P5028A-04

Information Only Service Note

P5028A Keysight Streamline USB Vector Network Analyzer

False alarm on self-test failure on firmware revision of A.13.40.02 - DDR3 memory removal

Self-test

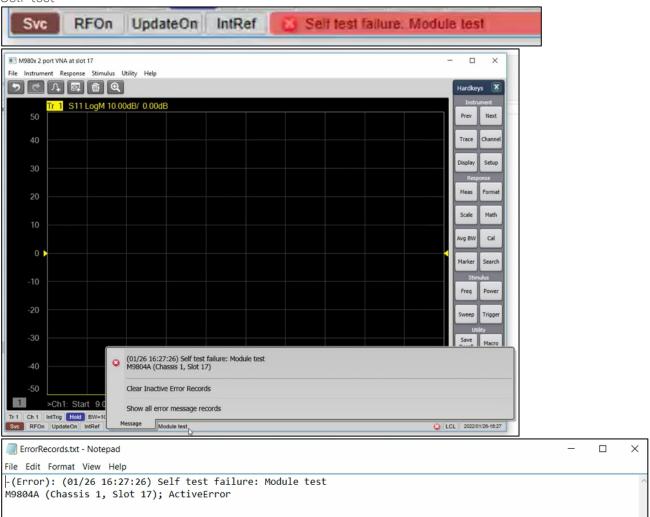
The on board DDR 3 memory in VNA is not in use since its release. With the removal of DDR 3 memory IC on newer P502xA VNA, right after firmware is launched, false alarm (self-test failure) will be reported as shown. This has no impact to VNA performance and specifications.

Similarly, firmware will report a false failure in Operator check. Shown are the error messages example on VNA firmware UI.

Since this DDR3 memory is not in use, newer firmware revision no longer consider it as the failure. Keysight recommends keeping VNA firmware up-to-date whenever it is possible.

For users with firmware revision of A.13.40.02, Update firmware to revision A.13.70.02 or newer to resolve this false alarm on self-test.
